## **APPENDIX G**

### **NMED COMMENTS ON FINAL DECOMMISSIONING PLAN SUBMITTED JANUARY 31, 2025 & LICENSEE RESPONSES**

Re: Final Decommissioning Plan  
Response to NMED Comments Issued February 26, 2025  
Thermo Eberline LLC, License No. SO067-36  
5981 Airport Road Facility  
Santa Fe, New Mexico

### Conceptual Auger Removal Plan

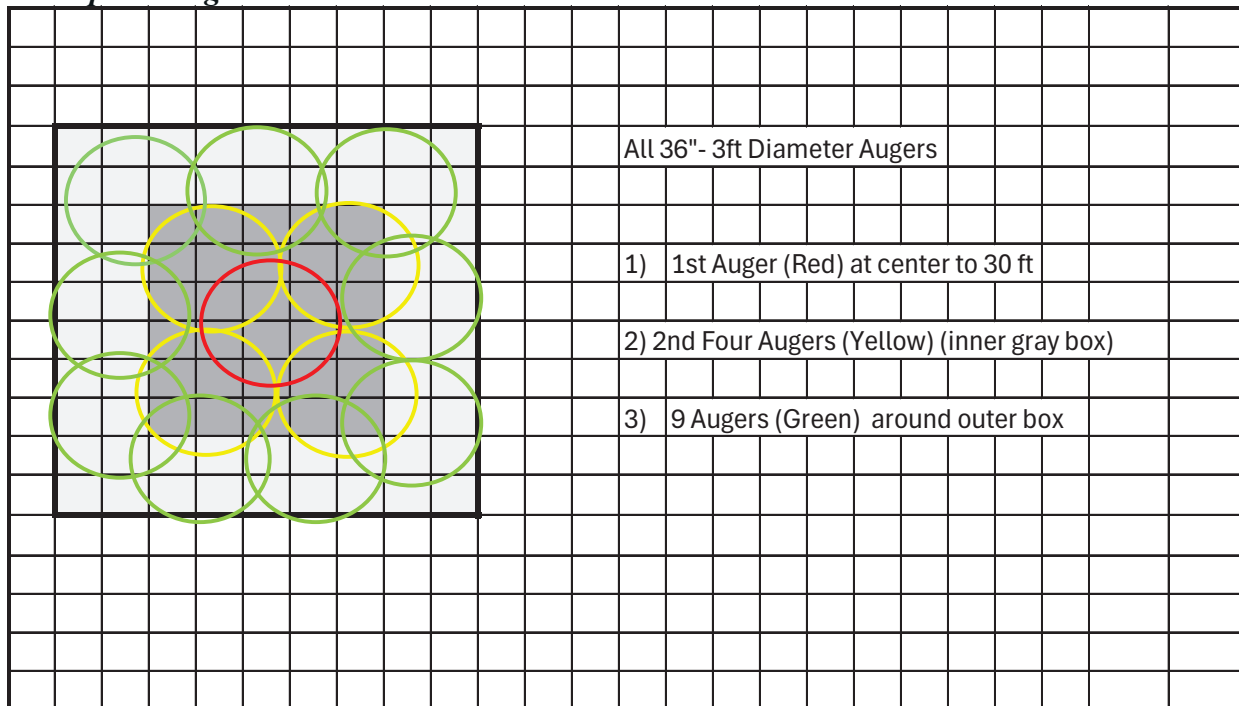
**NMED Comment 6: What augering techniques will be used to ensure that all or virtually all of the cesium-137 contaminants will be captured?**

Licensee Response 6: Section 7.3.2 Remediation Techniques and supporting documentation indicate that the in-place volume of Cs-137 impacted soil is less than 20 cubic yards (cyds). To ensure "all or virtually all" Cs-137 impact to soil from the HRW is removed, a targeted volume of soil 6 to 7 times greater than and surrounding the impacted zone will be removed (estimated at 140 to 150 cyds). This removal approach is commonly referred to as "over-excavation" and essentially involves removal of a buffer of clean soil around the impacted zone to account for unavoidable mixing that will occur during the removal process in an effort to meet cleanup objectives.

Below is a more detailed description of the Cs-137 removal process by augering that could be incorporated into Section 7.3.2 Remediation Techniques for Phase 3 decommissioning work, if approved by NMED:

*The extent of Cs-137 impacted soil has been conservatively estimated to be bound within an area 5 by 6 feet extending to 24 feet in depth. The actual volume of Cs-137 impacted soil within this area is estimated at less than 20 cubic yards. Removal by over-excavation using soil augers is demonstrated in the following conceptual approach. The actual approach to be employed will be a function of the actual equipment employed and may require modification. Assuming a three-foot diameter auger is used, the first boring (red) would be advanced at the*

center of the former HRW to a target depth of 30 feet or less (up to six feet beyond the 24 foot estimated extent to an underlying clay). Upon completion of the boring and monitoring the hole would be backfilled with clean soil. The next four auger borings (yellow) would be advanced to the same target depth at the locations indicated to remove both residual impacted and clean backfilled soil. Each boring would be backfilled with clean soil before moving to the next location. Upon completion of the set of four yellow auger holes, a final set of nine auger holes would be advanced around the perimeter of the four yellow holes. In total, 15 auger borings each 3 feet in diameter would be advanced over a 90ft<sup>2</sup> area. This approach results in over-excavation beyond the limits of impact by an estimated three feet in four directions and up to six feet vertically. The total estimate volume of impacted soil to be removed including expansion is estimated at 150 cubic yards (note the DP indicates 120 and this should be updated).
